Memorandum to the City of Markham Committee of Adjustment December 02, 2025

File: A/057/25

Address: 4611 Highway 7 East, Markham Agent/Applicant: Glen Schnarr & Associates Inc. Hearing Date: Wednesday, December 10, 2025

SITE PLAN
SCALE: 1:200

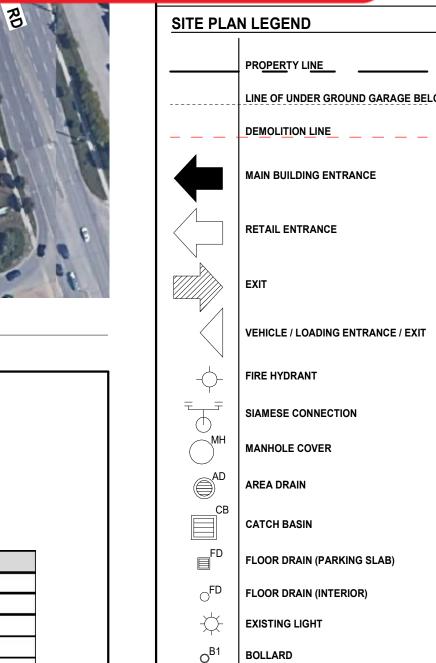
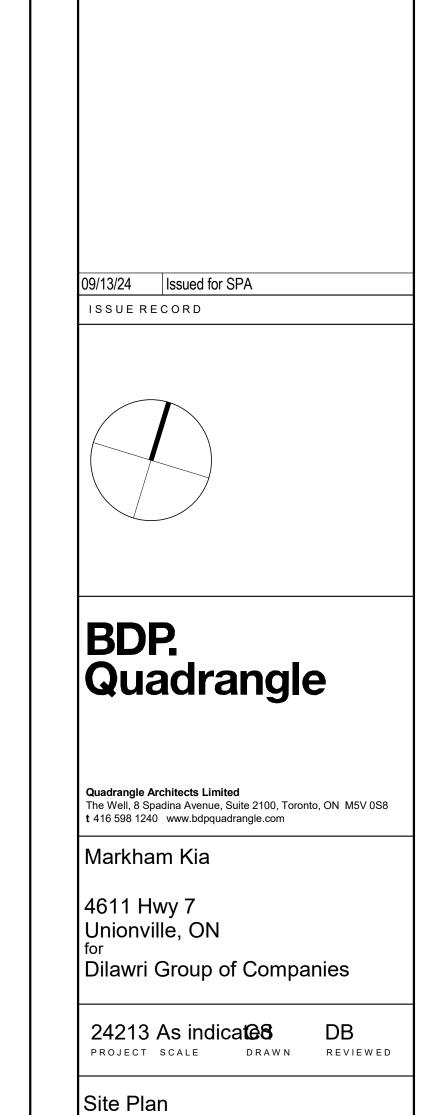
#	TRCA Comments
1	Although TRCA staff have no concerns with the proposed variances, staff ask that the future electric car charging spaces be relocated outside of the Regulatory Flood Plain and its associated 10-metre setback.
2	The applicant submits the TRCA plan review fee of \$1,250 within 60 days of the committee hearing date.
3	The applicant seeks and is issued a permit by TRCA pursuant to the Conservation Authorities Act.
